General Bid Bulletin No. 15
16 July 2021

**THE MALOLOS-CLARK RAILWAY PROJECT AND THE NORTH-SOUTH RAILWAY
PROJECT SOUTH LINE COMMUTER PACKAGE CP NS-01: PROCUREMENT OF
ELECTRICAL AND MECHANICAL SYSTEMS AND TRACK WORKS (IFB No: 21-040-3)**

PACKAGE CP NS-01: E&M SYSTEMS AND TRACK WORKS
General Bid Bulletin No. 15
Annex A

PACKAGE CP NS-01: E&M SYSTEMS AND TRACK WORKS
General Bid Bulletin No. 15
Annex B

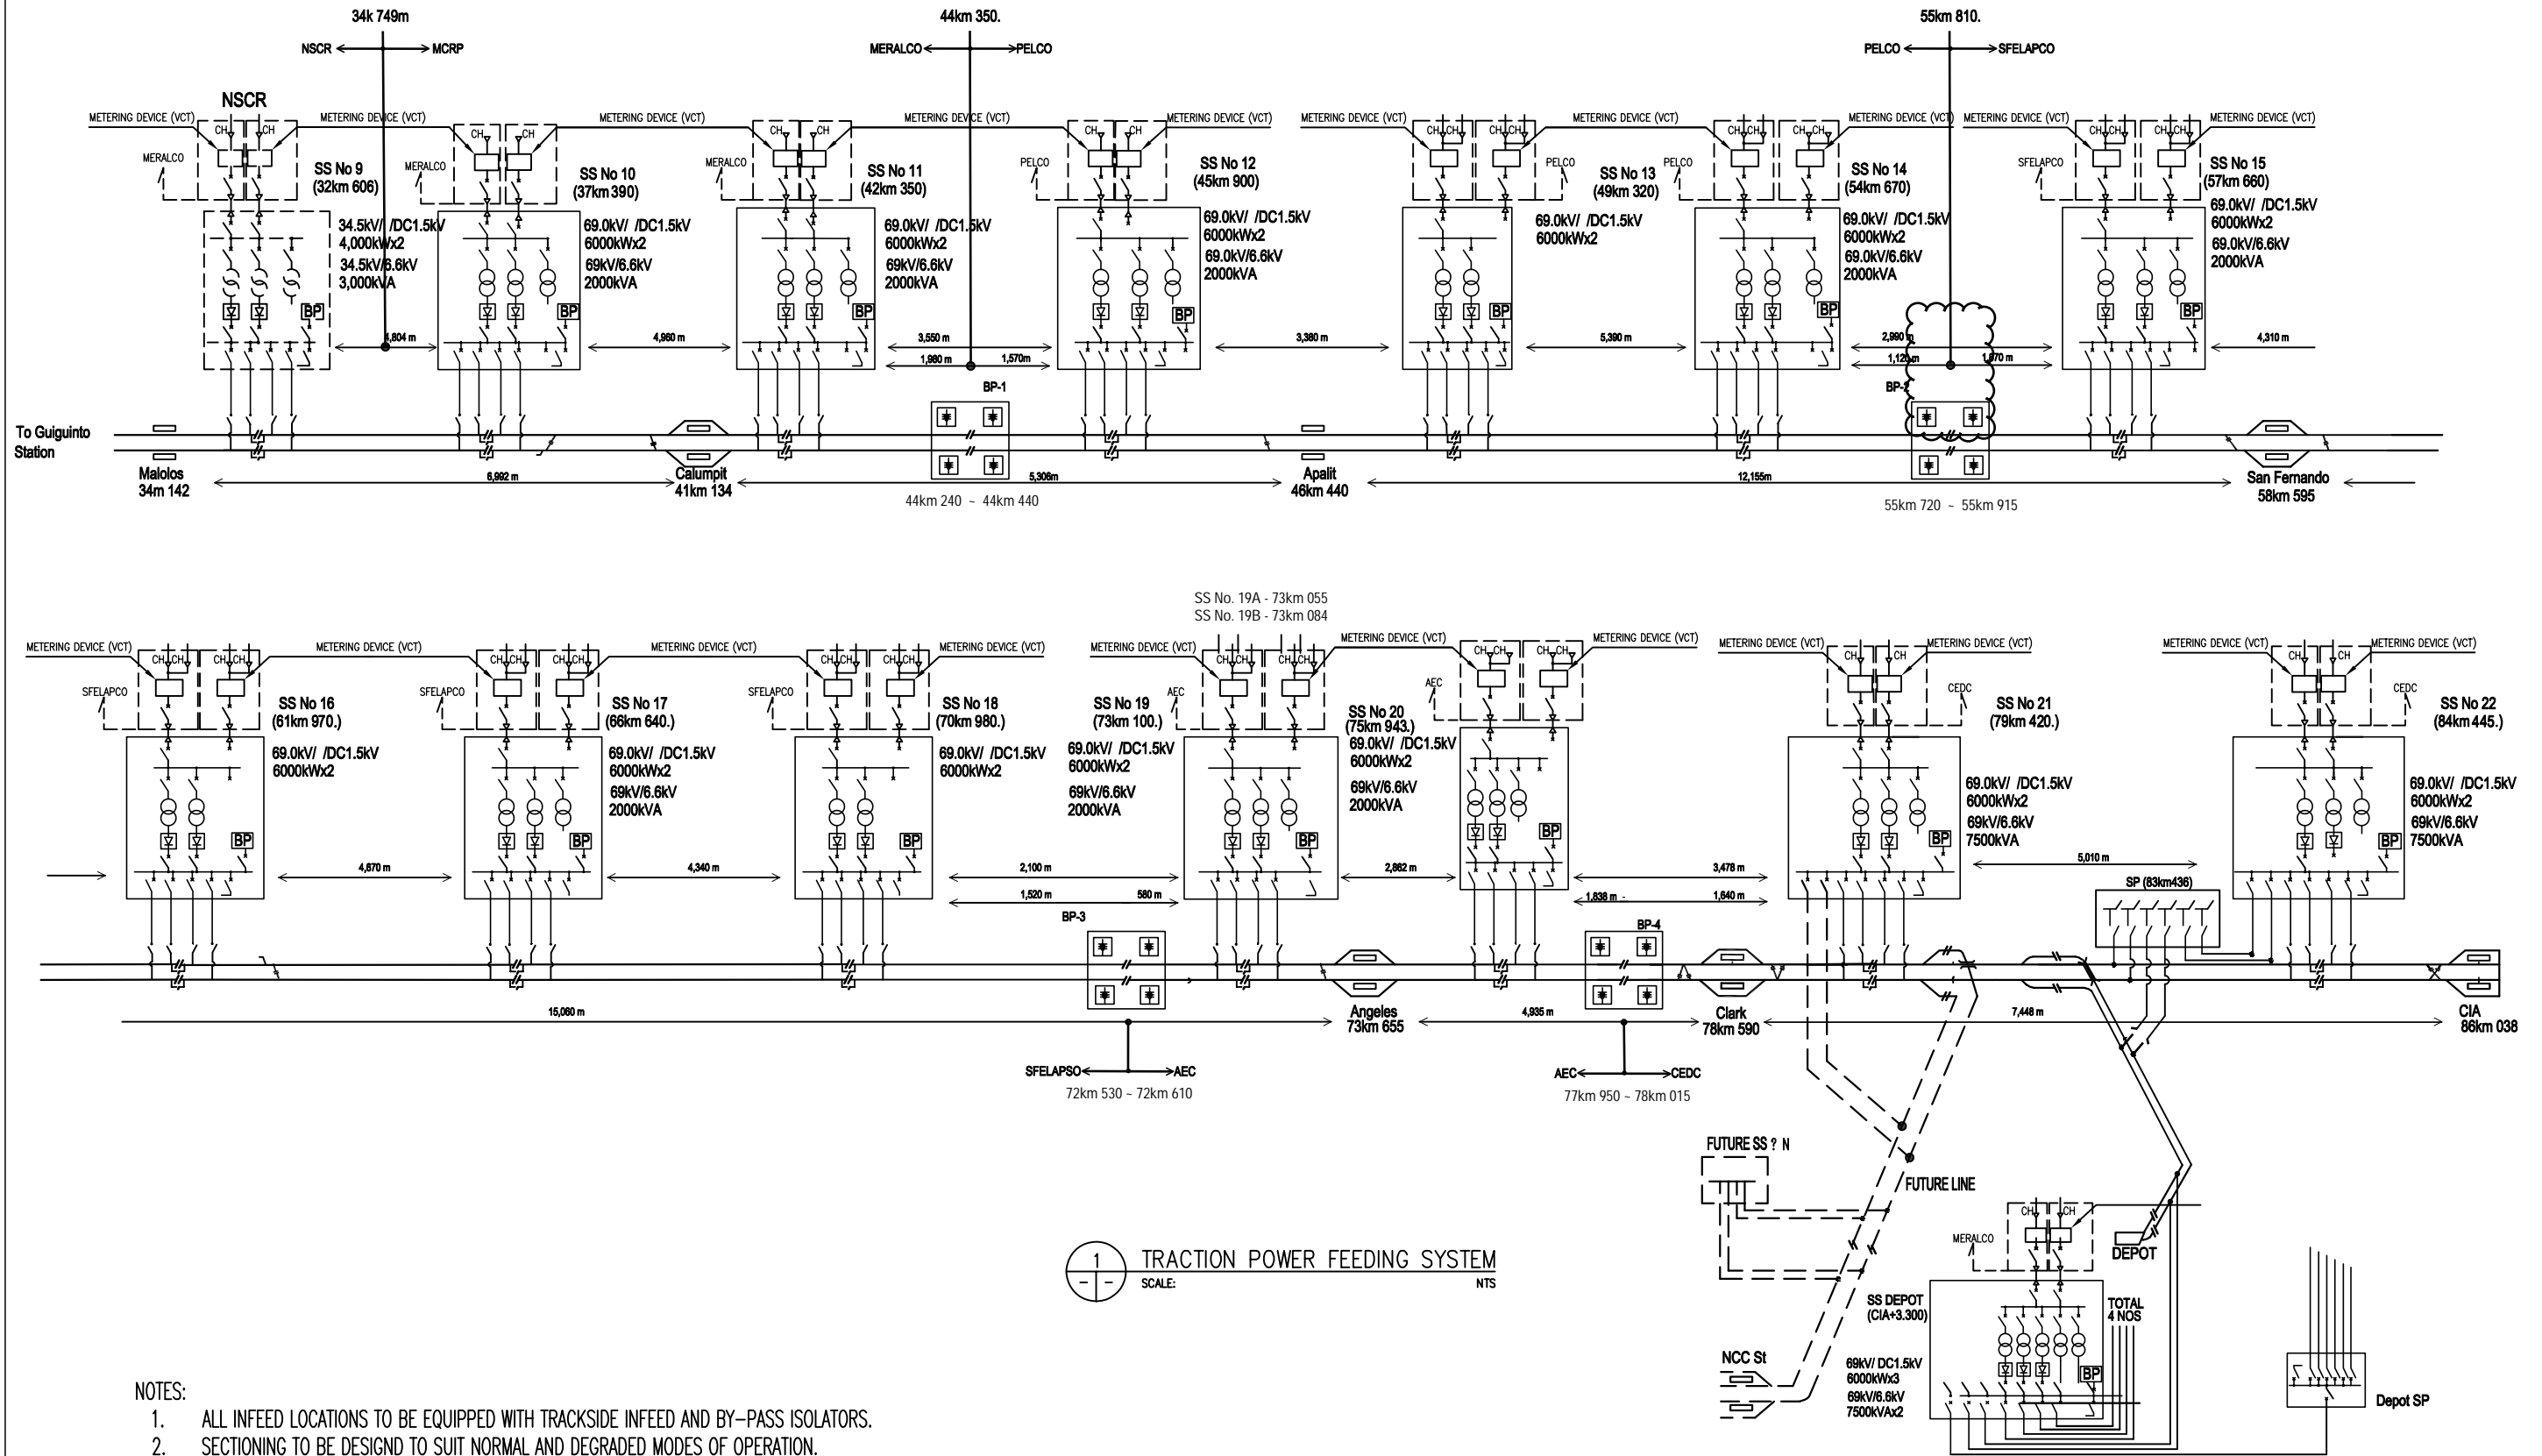
Volume III Part 2 – Employer’s Requirements d) Employer’s Drawings		
7	Part 2 Vol.3 E_M Version 11.0 FINAL Rev. A. ERD (a) page 164	Revised Traction Power Feeding System Drawing
8	GBB-9 Annex B, Item No.16	Substation Layout Drawings (SS No. 10) to (SS No. 22) “Local Annunciator Panel Added”

MALOLOS – CLARK RAILWAY PROJECT (MCRP)
 NORTH SOUTH RAILWAY PROJECT-SOUTH (NSRP-SOUTH)
 Package CP NS-01 : Bidding Documents
 SUBSTATION LAYOUT
 (SS No. S10)

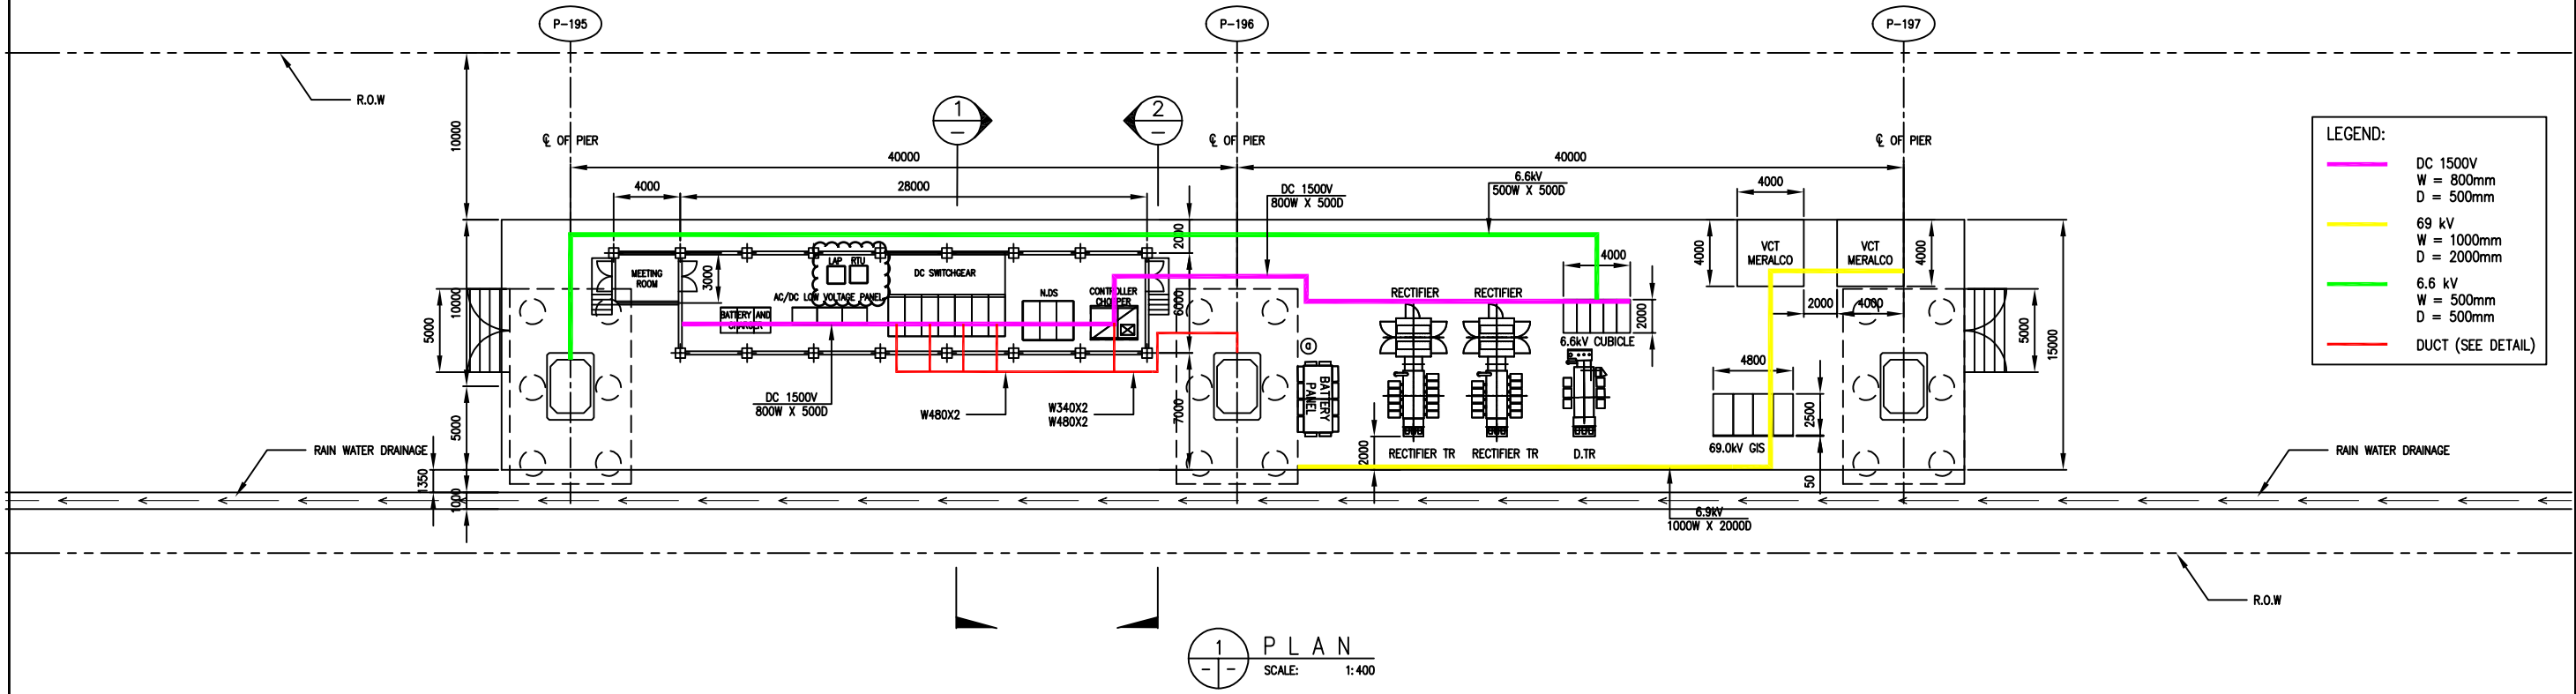
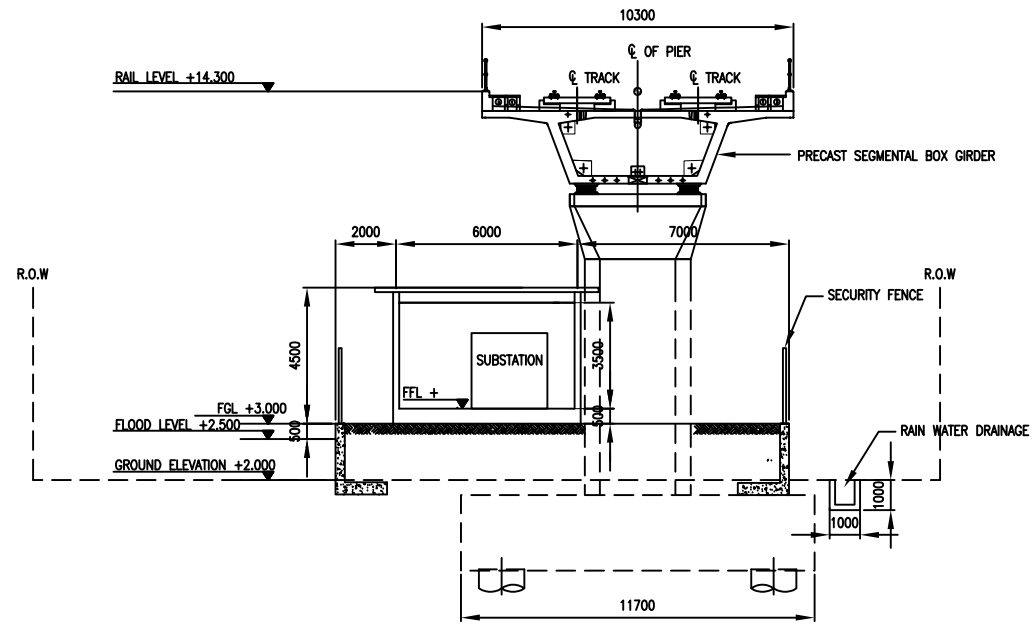
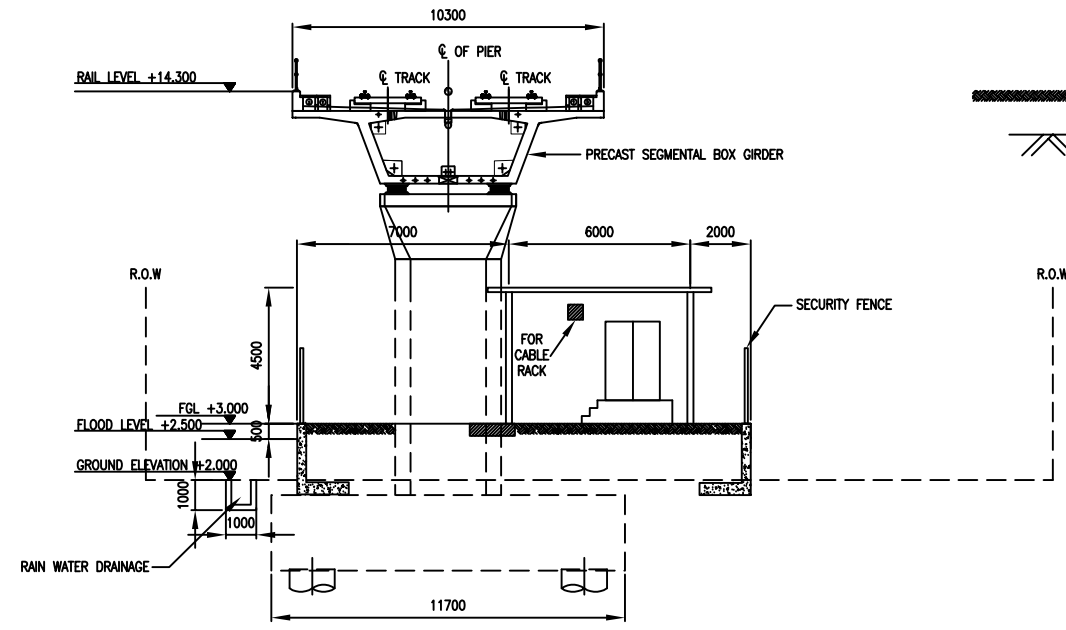
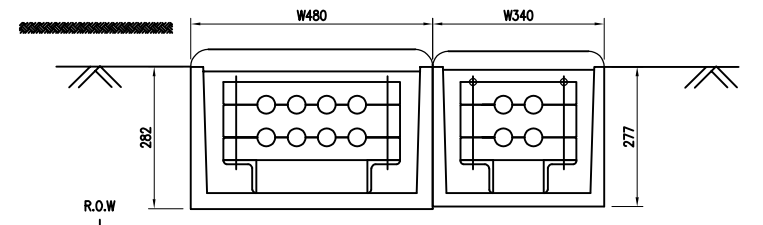
VERSIONS	DATE	DESCRIPTION
00	02 MAR 2021	ISSUED FOR REFERENCE
01	09 JUN 2021	RESISTOR CHANGED TO BATTERY POST
02	24 JUN 2021	LOCAL ANNUNCIATOR PANEL ADDED

MALOLOS - CLARK RAILWAY PROJECT (MCRP) NORTH SOUTH RAILWAY PROJECT-SOUTH (NSRP-SOUTH)	
Package CP NS-01 : Bidding Documents	
SUBSTATION LAYOUT (SS No. S11)

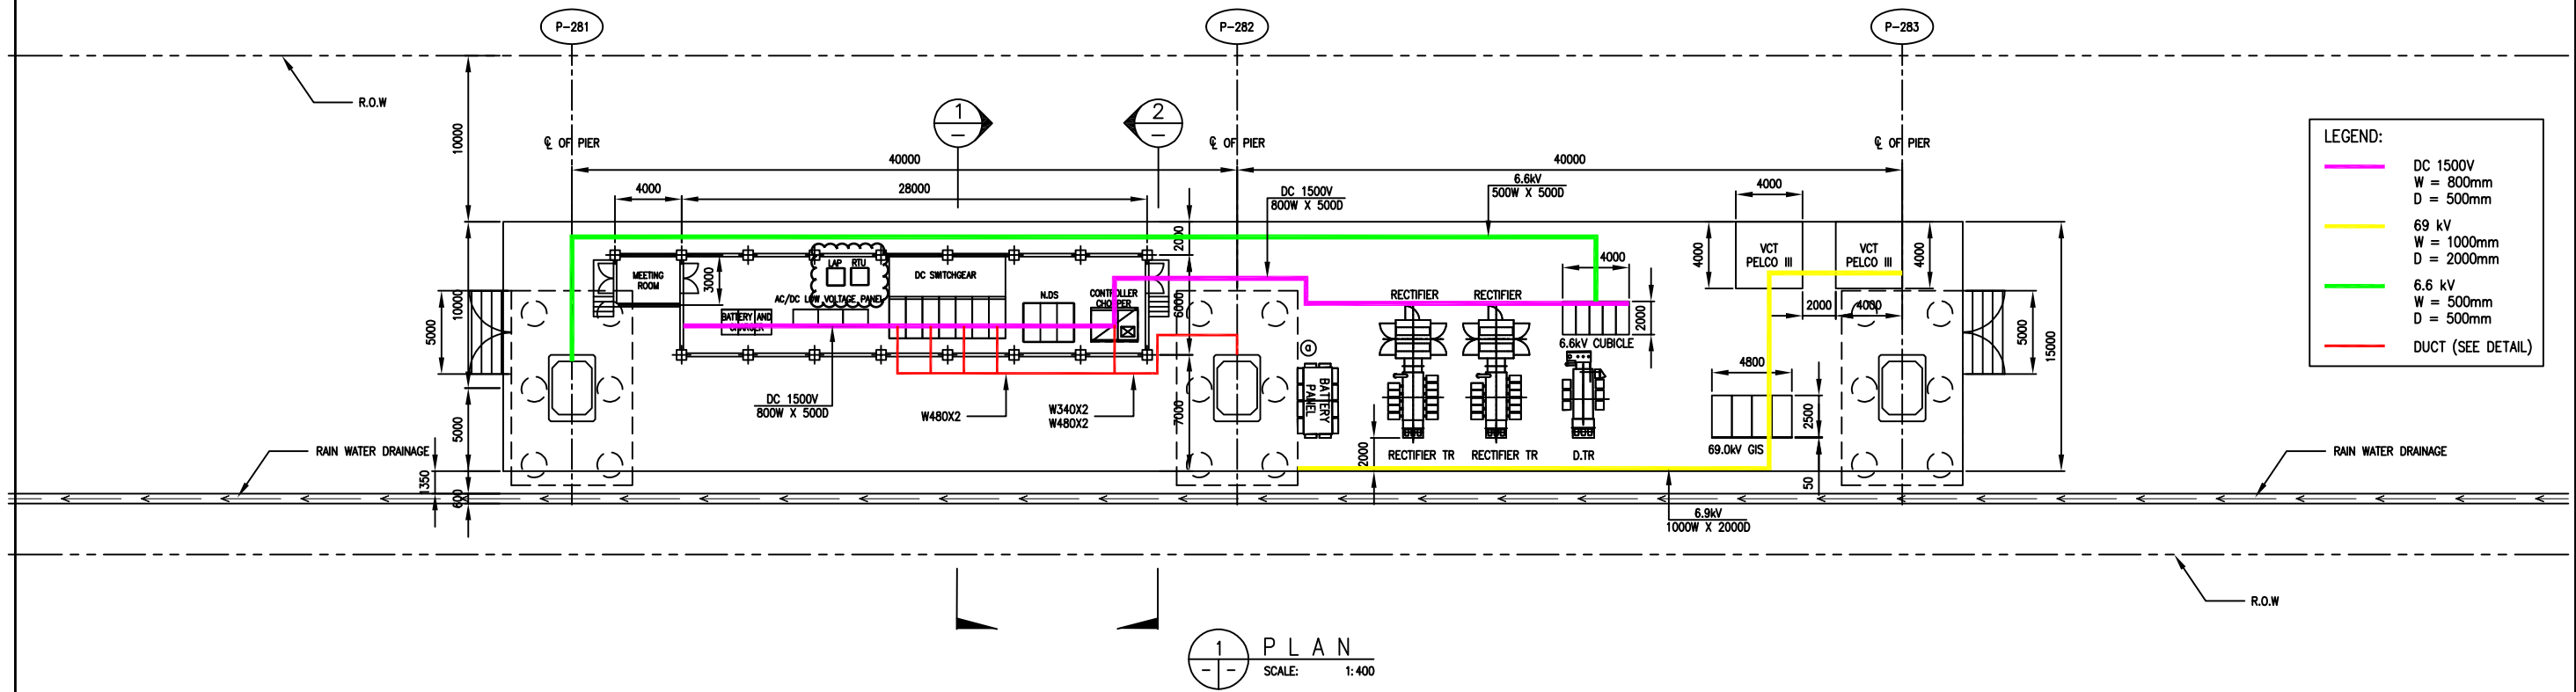
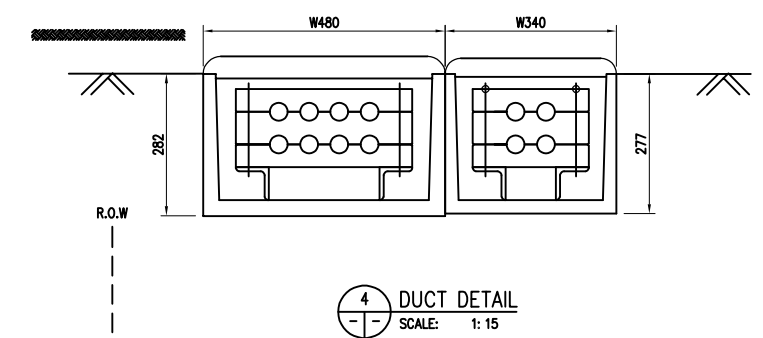
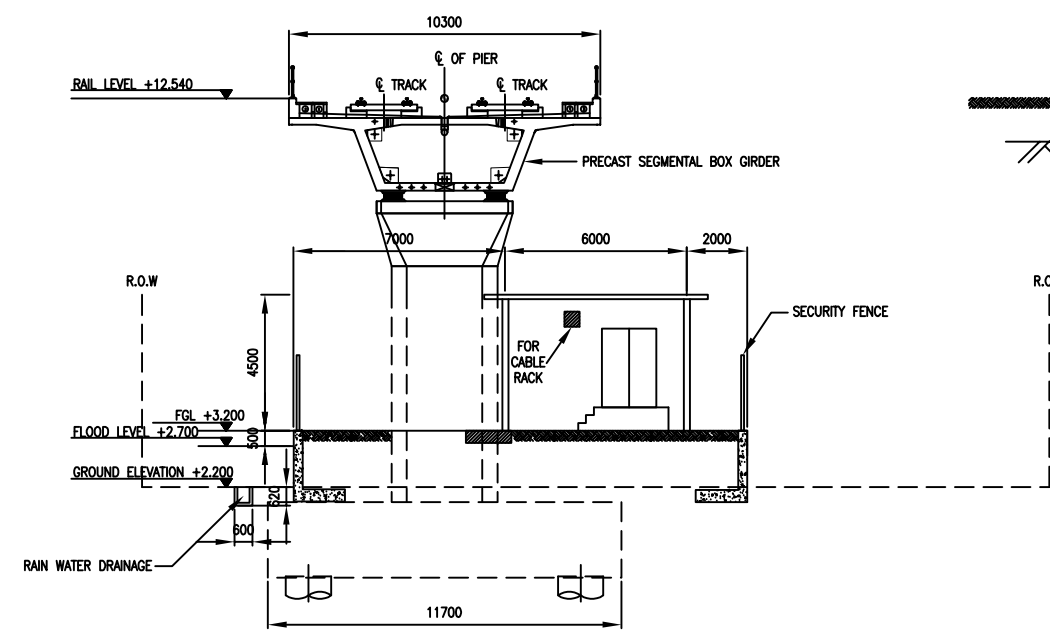
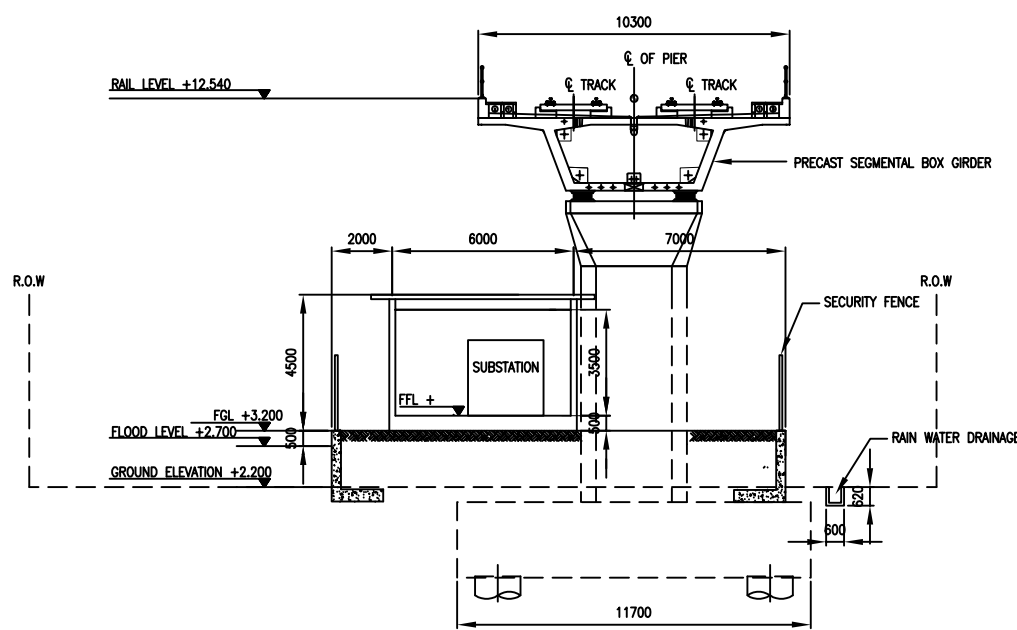
VERSIONS	DATE	DESCRIPTION
00	02 MAR 2021	ISSUED FOR REFERENCE
01	09 JUN 2021	RESISTOR CHANGED TO BATTERY POST
02	24 JUN 2021	LOCAL ANNUNCIATOR PANEL ADDED
